Reviewed For Code Compliance By:
D. Banks Wallace
Chief Deputy Fire Marshal
12/03/2018 11:01:25 AM

TITLE/PROJECT INFO:
COVER SHEET - SITE PLAN
COBLE SKI SCHOOL
LILLINGTON, NC 27546

REVISED 10.15.2018		JAMES R. BASINGER, PE CONSULTING ENGINEER 242 PLEASANT VILLAGE LANE CHINA GROVE, N.C. 28023 704-975-9415 (fax) 704-750-1410 (mobile)	PROJECT NO. 17014	TITLE/PROJECT INFO: PRO-SHOP - MEETING ROOMS - REVISED 130 COBLE SKI EST. COBLE SKI SCHOOL LILLINGTON, NC 27546	SHEET NO. 1
		engineering design consulting	DATE 6 JAN 2018 DRAWN BY: JRB

1 PRO SHOP & MEETING ROOMS - FIRST FLOOR
SCALE: 1/8" = 1'-0"

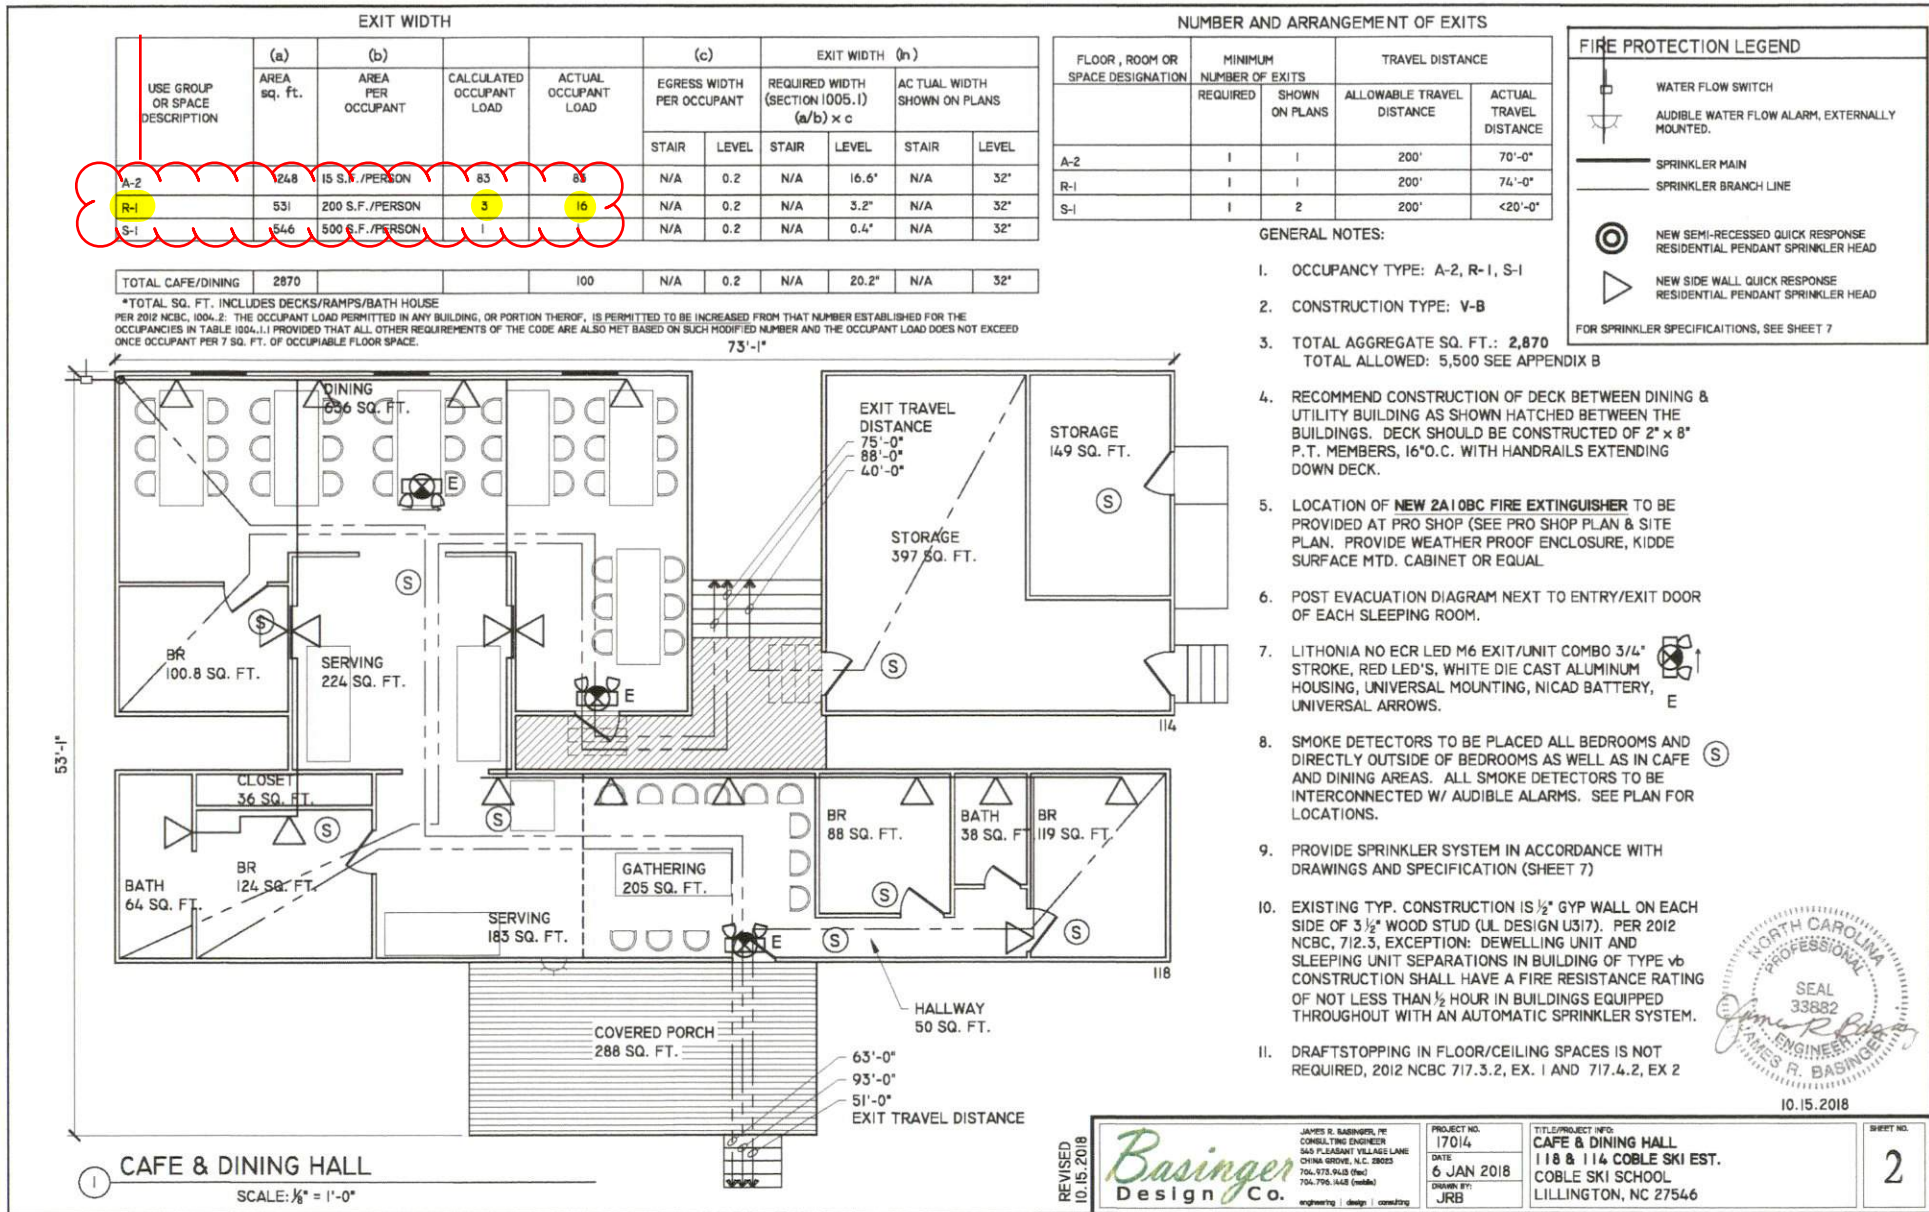
Post Occupant Load

Please clarify

1 SUITES
SCALE: 1/8" = 1'-0"

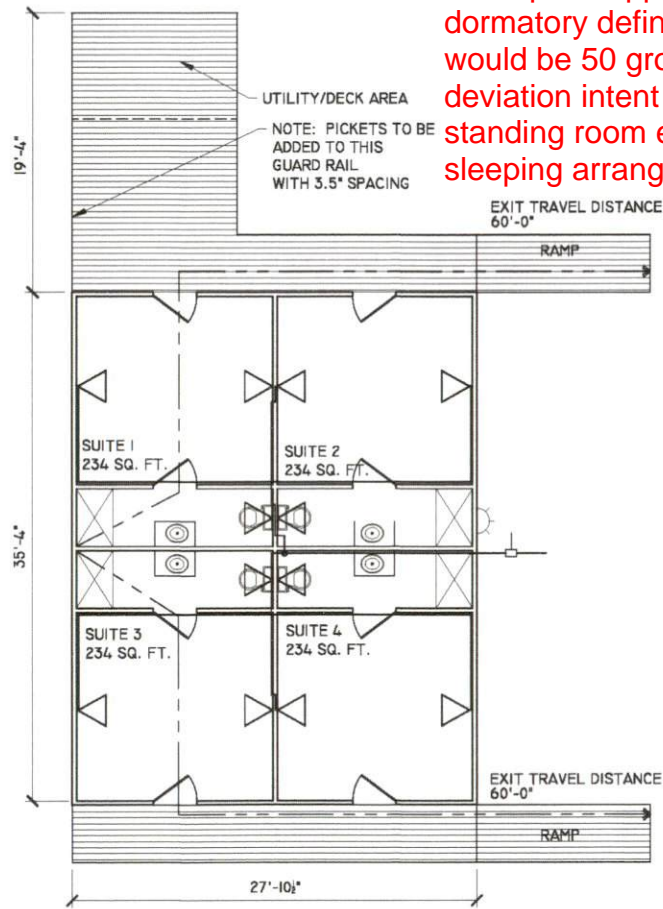
This space appears to meet the dormitory definition which would be 50 gross; 1004.2 deviation intent is based on standing room events, not sleeping arrangements.

1 CAMP ROOMS
SCALE: 1/8" = 1'-0"

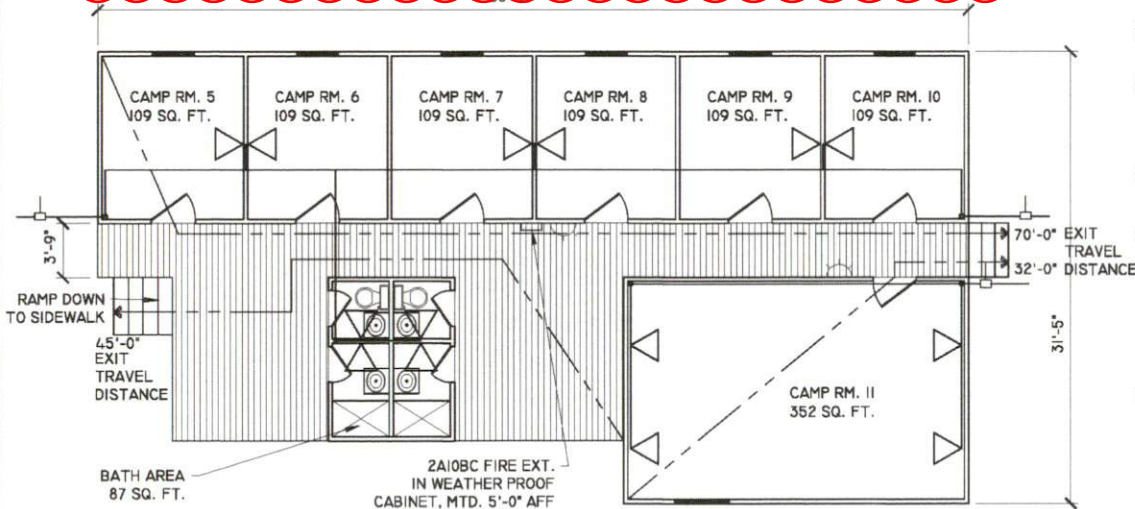
This space appears to meet the dormitory definition which would be 50 gross; 1004.2 deviation intent is based on standing room events, not sleeping arrangements.

1 STAFF ROOMS

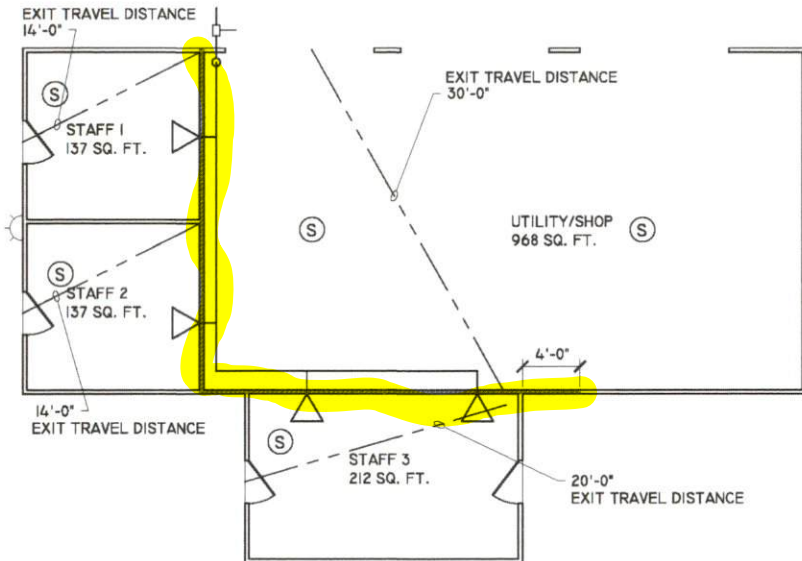
This space appears to meet the dormitory definition which would be 50 gross; 1004.2 deviation intent is based on standing room events, not sleeping arrangements.

1 HOOCH
SCALE: 1/8" = 1'-0"

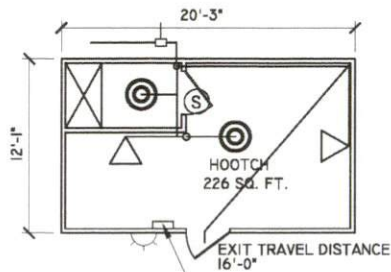
This space appears to meet the dormitory definition which would be 50 gross; 1004.2 deviation intent is based on standing room events, not sleeping arrangements.
